# Winterbourne Wind Farm

Amendment Report

3 October 2024

0526676

**3-2 Amended Project Layout**  
Page 1 of 4

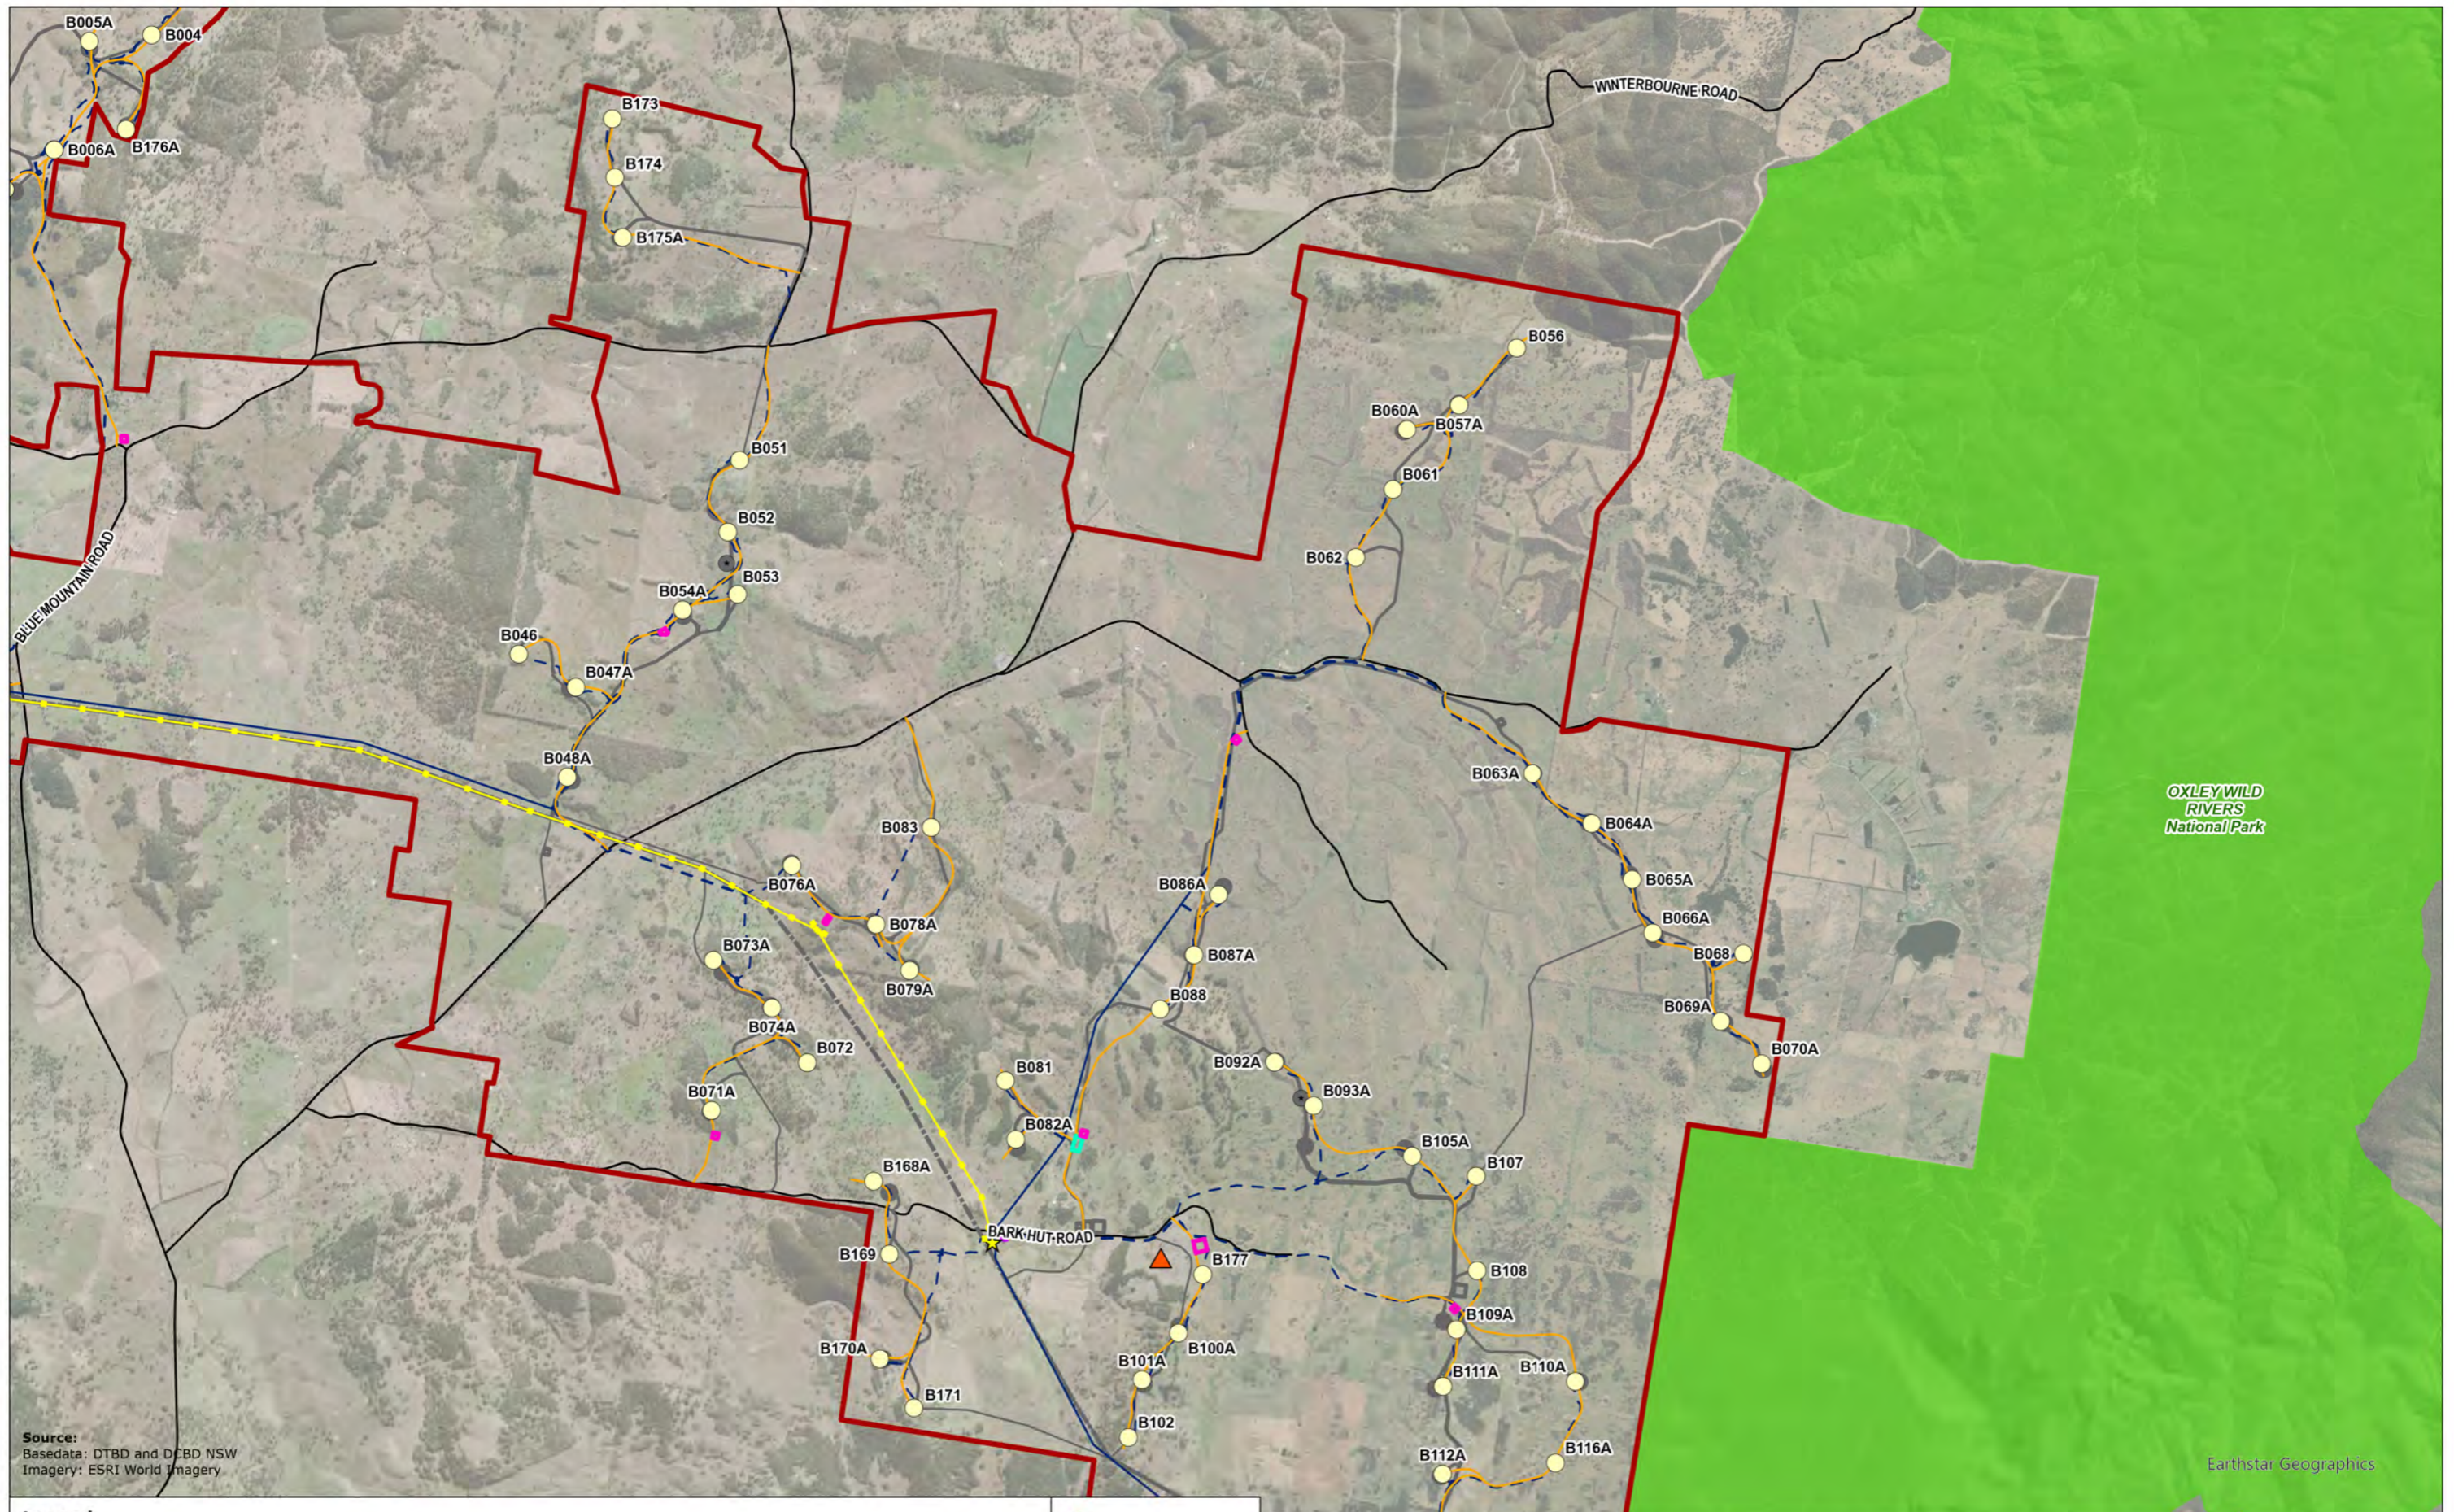
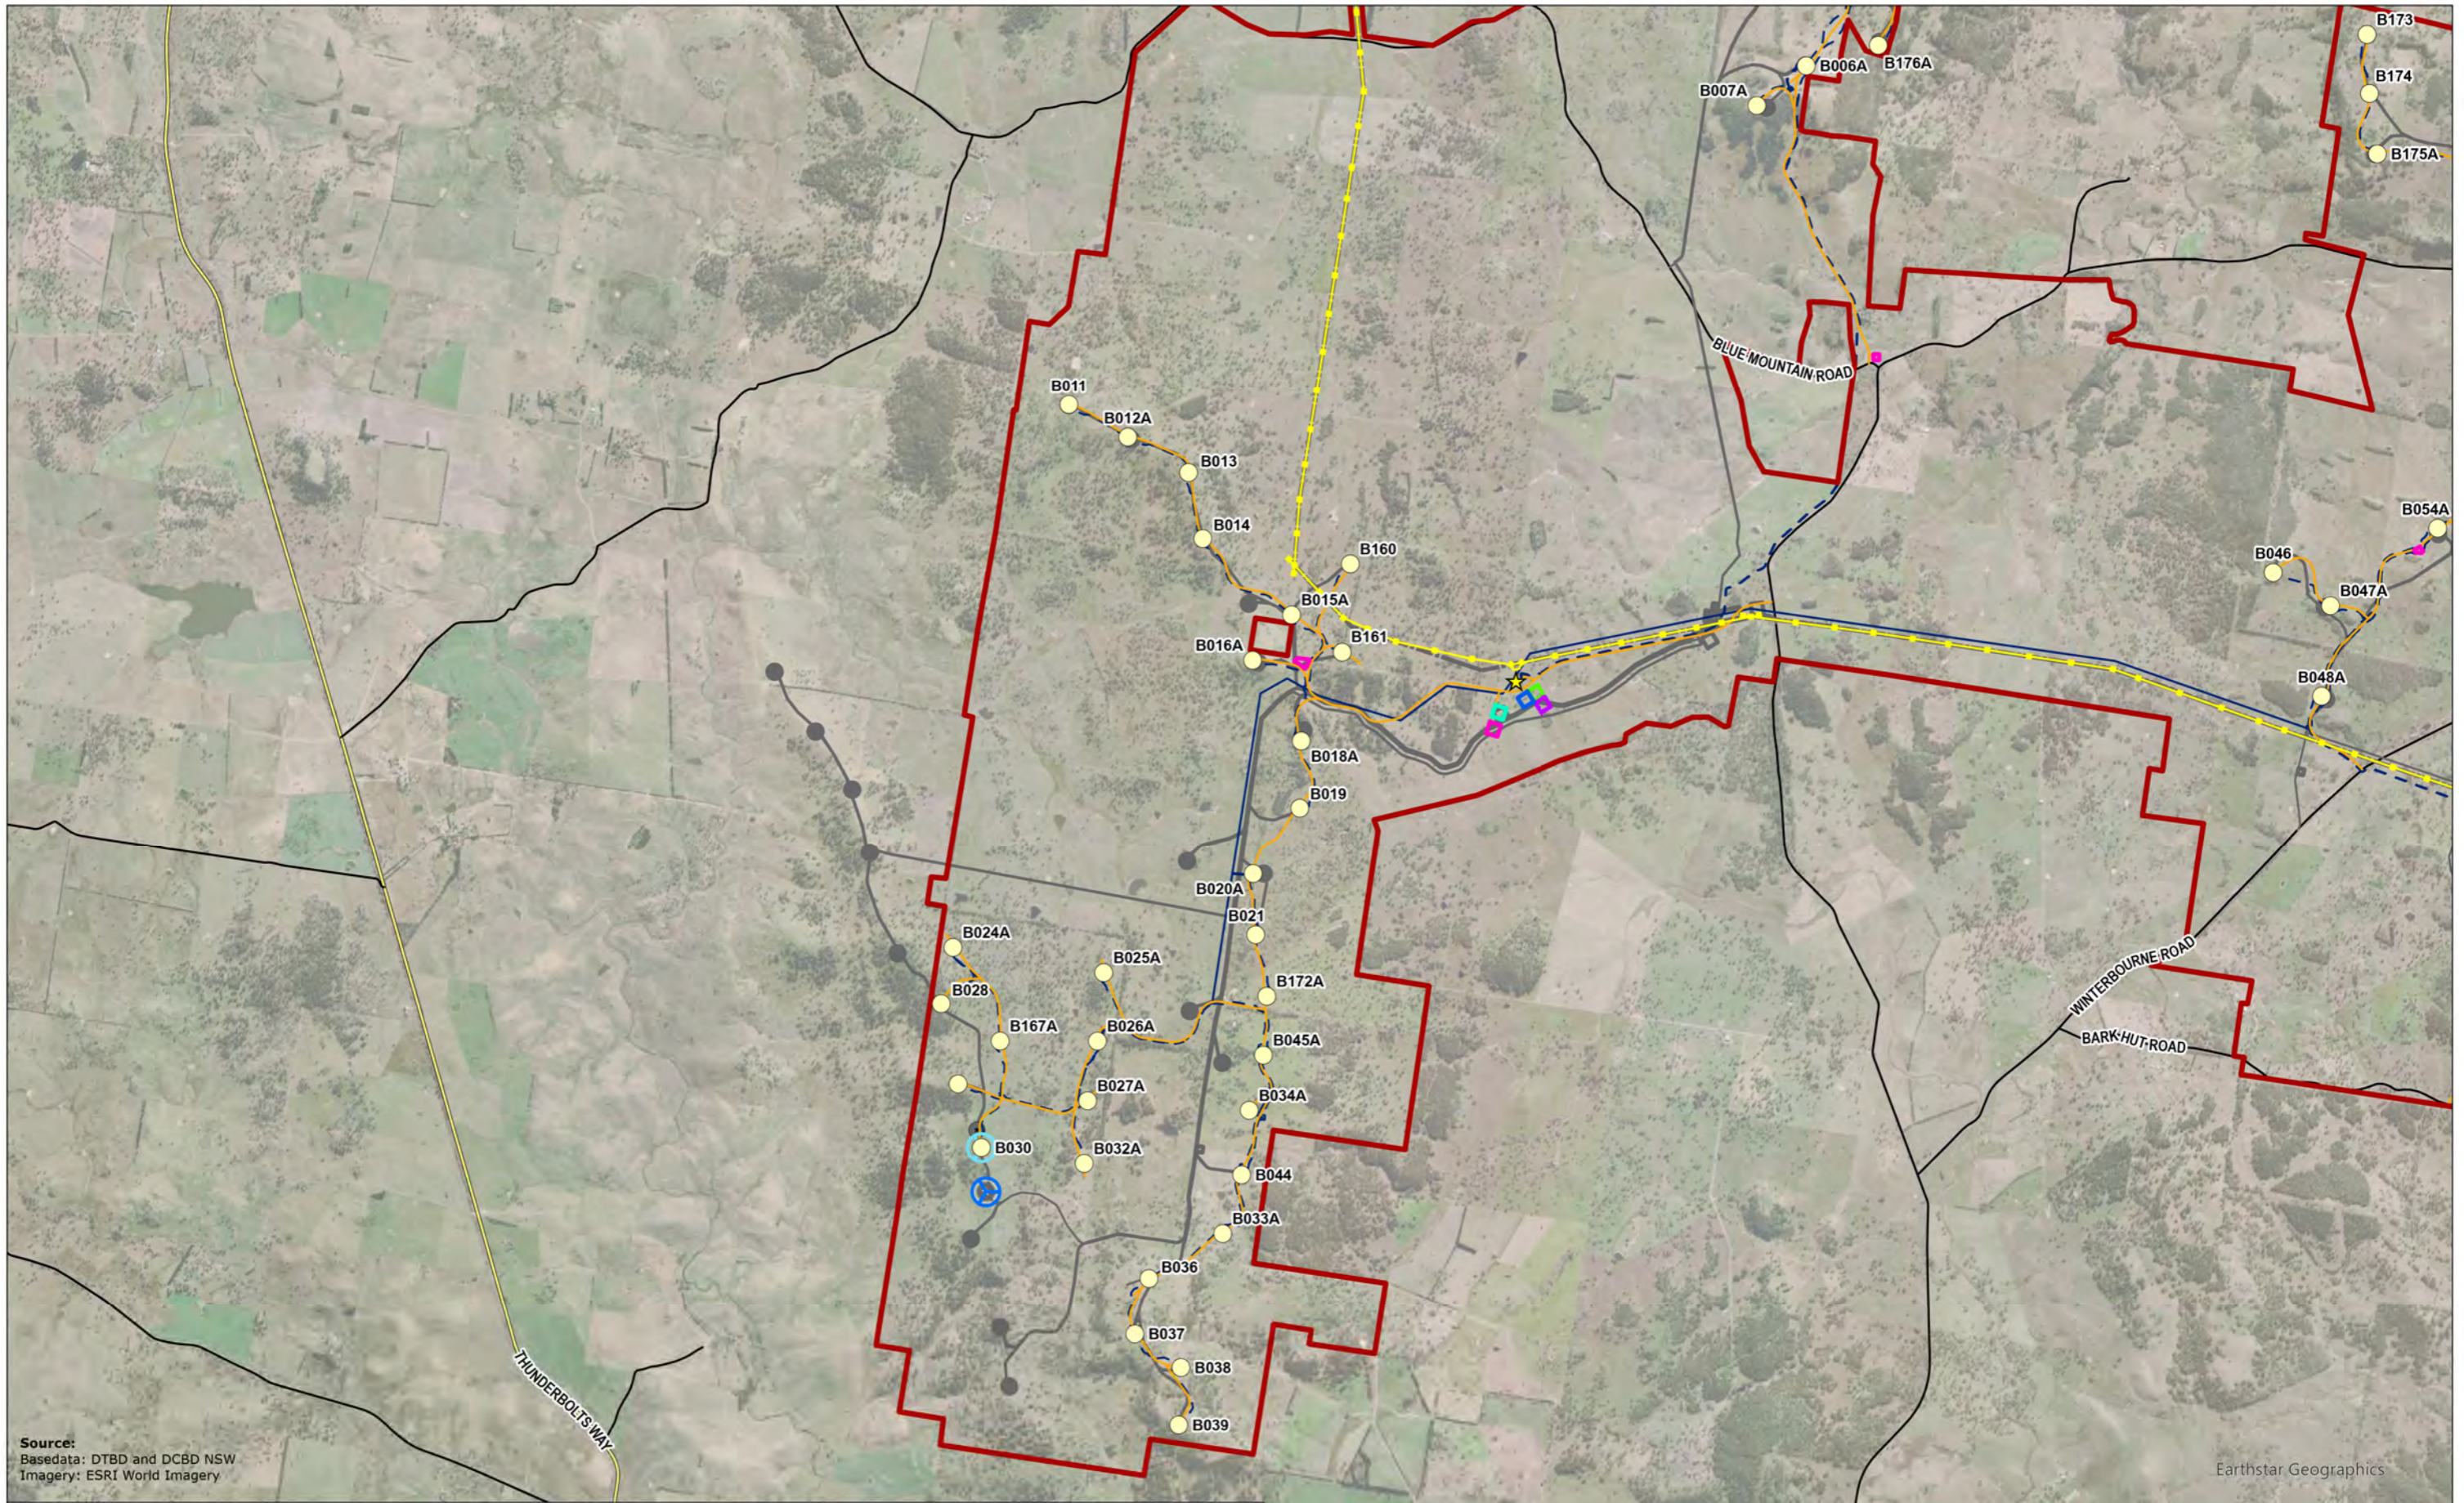
Amendments include relocation and/or removal of elements of the Project, as well as optimisation of other project infrastructure areas. The amended Project Area is shown in **Figure 3-1**. The amended Project Layout is shown in **Figure 3-2**.

The Applicant has refined the Project design in response to agency advice and public submissions received, as well as constructability considerations. These design refinements include:

- Refinement of two (2) WTGs to provide at least 600 m buffer from the WTG to the National Park boundary;
- Refinement (<100m movement) of three (3) WTGs and relocation (>100m movement) of two (2) WTGs to address concerns raised by NSW Telco Authority relating to potential impacts to point-to-point telecommunication links;

- Revised site access along public roads to match revised internal access track layout;
- Realignment of underground electrical reticulation and addition of four sections of overhead 33 kV electrical transmission line to reduce biodiversity impact;

- Relocation of north substation, maintenance building, construction compound, BESS and laydown area approximately 1.8 km west to improve constructability, reduce biodiversity impact and provide a greater buffer between infrastructure and public roads;
